# NORTH SYDNEY COUNCIL REPORTS

# **NSLPP MEETING HELD ON 07/05/2025**

ADDRESS/WARD: 48 Raymond Road, Neutral Bay

APPLICATION No: DA384/24

Figure 20: Council's calculation of maximum height proposed (highlighted yellow)

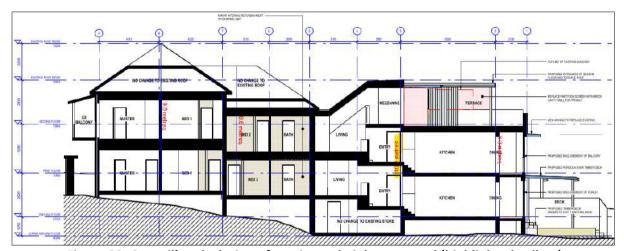
The proposed works would have a height of 10.2m that does not comply with the permissible height limit of 8.5m in accordance with clause 4.3 in *NSLEP 2013*. This is calculated from the Lower Ground Floor FFL of the existing storeroom to the proposed roof. The existing site has a maximum height measured to be 10.2m measured from the same location. The proposed works do not exceed the ridge height of the existing building at this location and due to the topography of the subject land is located lower than the front portion of the building fronting Raymond Road.

Figure 20 (left): Proposed new roof area
Figure 21 (right): Proposed extended internal area to Mezzanine

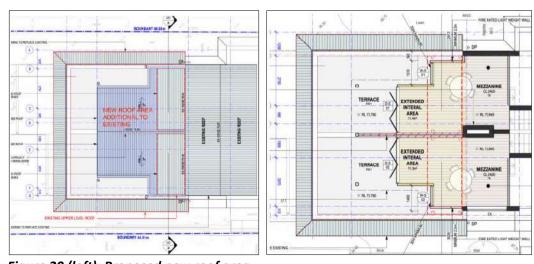
The Clause 4.6 submission is considered to be well founded in the circumstances as there are no adverse material impacts that result from this application and that the design new roof pulls in 1.4 from the south side and 1.85m from the north side, immediately after the extent of the existing awnings.

The submission is considered to have demonstrated the achievement of the objectives of the R2 Low Density Residential zone on the basis that the proposal is remains as a two-storey form from Raymond Road and improves amenity for the occupants of the dwelling through BASIX compliance and fire safety upgrades and provide roof cover for the outdoor rooftop terrace, while not adversely impacting view, solar access or privacy for surrounding properties. The proposed works maintain the same height as that existing (10.2m to the roof of the mezzanine) with a lower height for the proposed roof over the rear extension to the west of the mezzanine.

# No.44 Raymond Road

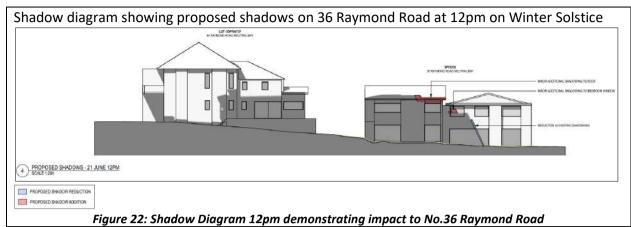
The Applicant provided certified shadow diagrams that demonstrate no additional shadows fall onto No.44 Raymond Road through the subject proposal at winter solstice between 9-3pm.

Figure 23A: Measurement of extension of mezzanine (blue) and extension of roof over terrace calculated from the mezzanine extension (orange)

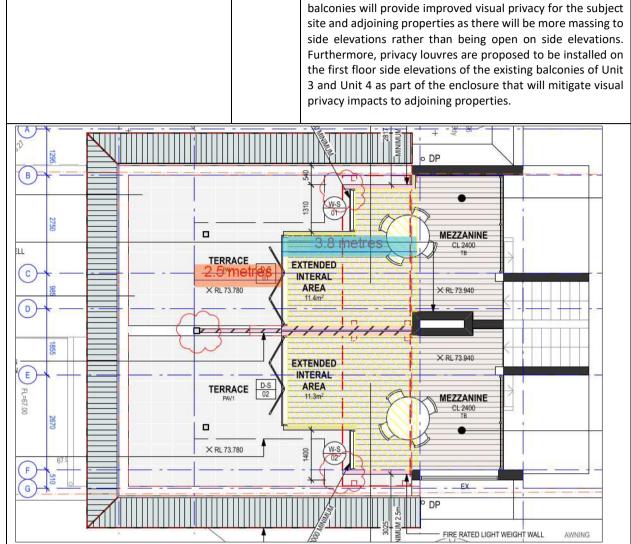
1.3.10	Visual Privacy	Yes	The proposed works take place within the existing building footprint. The rooftop terrace as existing is not proposed to be expanded in form and scale. The subject proposal seeks to enclose approximately 23sqm of the rooftop terrace for the mezzanine extension (refer to <i>Figure 23A</i> , highlighted blue, extended from the existing mezzanine to the west by 3.8m) and extension of the roof for a covered terrace area (highlighted orange, extended a further 2.5m from the proposed mezzanine extension). The proposal does not create greater visual privacy impact where the rooftop terrace is already of a residential use. Furthermore, views from the mezzanine to the west is more likely to be viewed horizontally across at eye level at the North Sydney district views rather than focus downwards and the lower topography of sites further west. At a seated position within the mezzanine extension, it is even more unlikely for the viewer to be capable of looking west past the open terrace parapet and down to the sites that slope down further to the west of the subject
